DIVISION OF RECLAMATION, MINING AND SAFETY

From: Tim Cazier, P.E.

Date: October 30, 2012

**Re: Permit No. M-2012-032, Revenue Mine Surface Water Systems Designs –
General Stormwater Comments**

Map G-2:

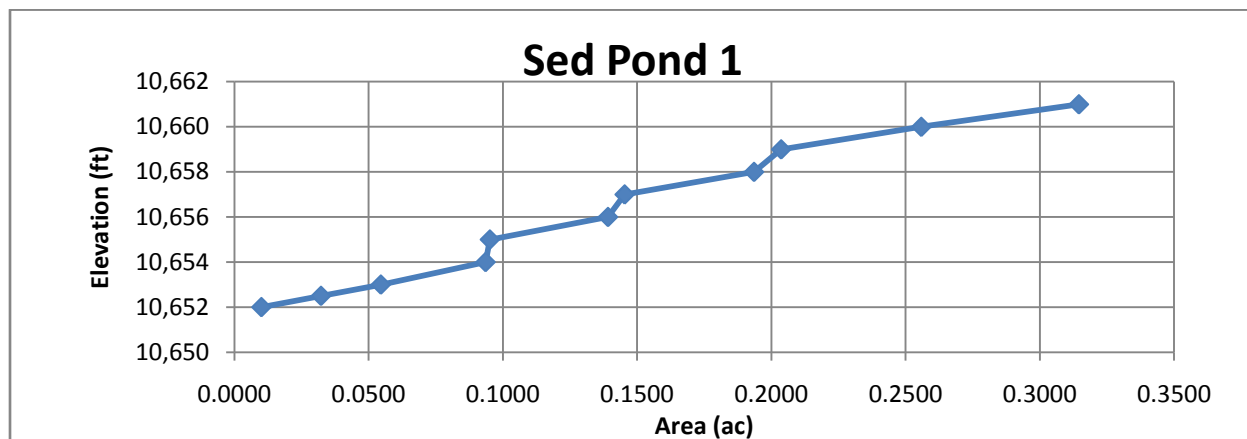
13. There appear to be errors in the storage volume computations. Based on the shape of Sediment Pond 1, the relation between the elevation and the area should be nearly linear and smooth. The plot below suggests area errors at elevations 10655, 10657, and 10659. Please review and correct these errors.

Map G-3:

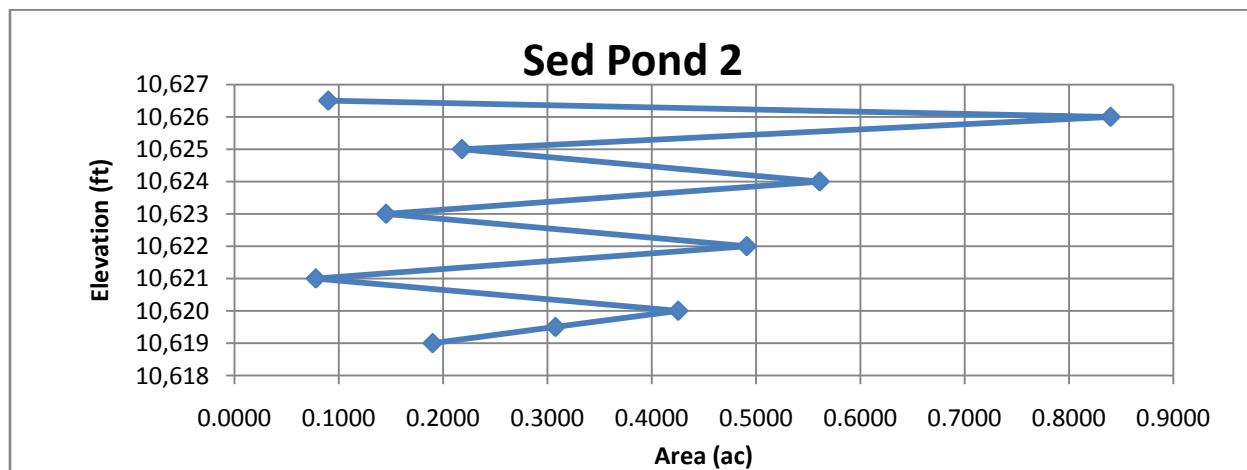
17. As the site is a DMO, any embankment fill is considered an EPF. Please include embankment material fill and compaction specifications.
18. There appear to be errors in the storage volume computations. Based on the shape of Sediment Pond 2, the relation between the elevation and the area should be nearly linear and smooth. The plot below suggests several area errors. Please review and correct these errors.

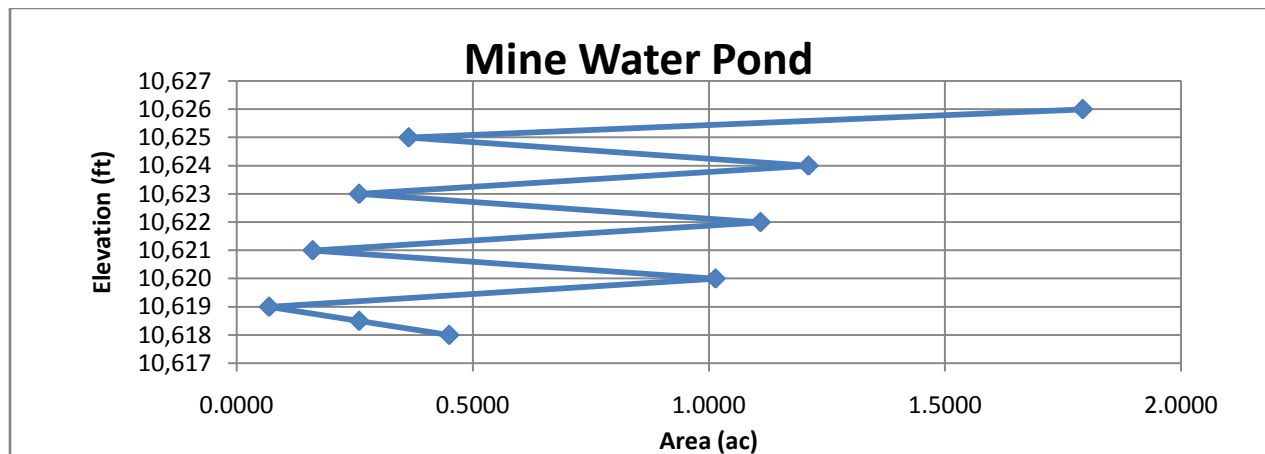
20. Please describe the purpose of the 12-inch HDPE pipe to Pond #3. Where does this pipe come from? Where is Pond #3?
21. As the site is a DMO, any embankment fill is considered an EPF. Please include embankment material fill and compaction specifications.
22. There appear to be errors in the storage volume computations. Based on the shape of the Mine Water Pond, the relation between the elevation and the area should be nearly linear and smooth. The plot below suggests several area errors. Please review and correct these errors.
